CONDENSER

MARK NO. 634-R2 NO. REQD.

BERGEN-PATERSON PIPESUPPORT CORP.

DATE	BY	CHKD	APP'D
17 NOV. 67	H	S	
JOB NO. P-60-1262-Y1			
DWS. NO. 180-1

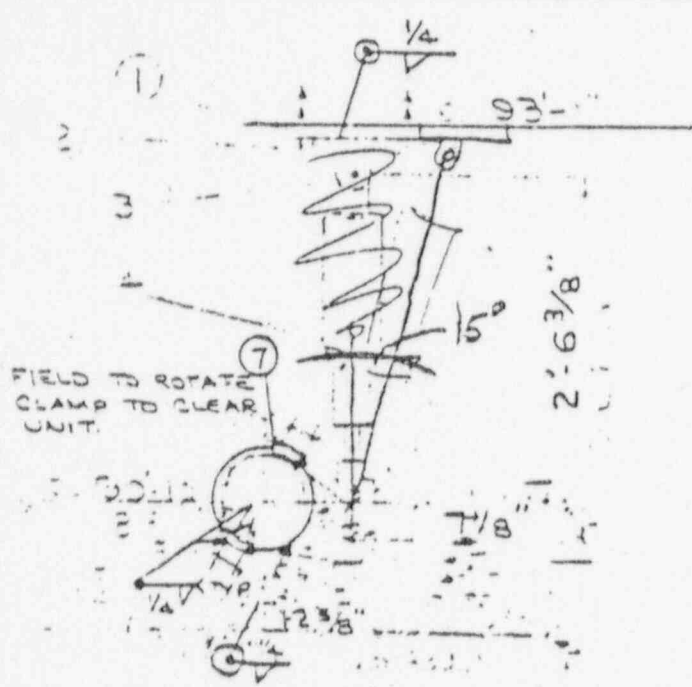
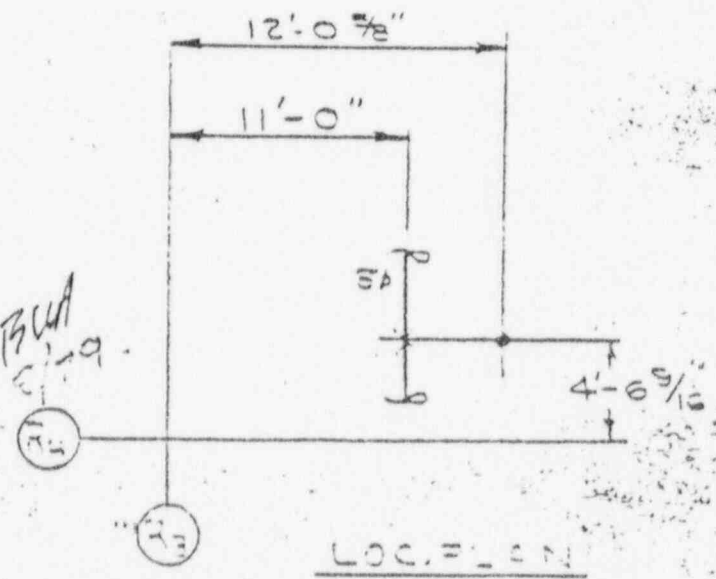
ADDED ITEM #7 & REV'D WELDS

FIELD TO ROTATE CLAMP TO CLEAR UNIT.
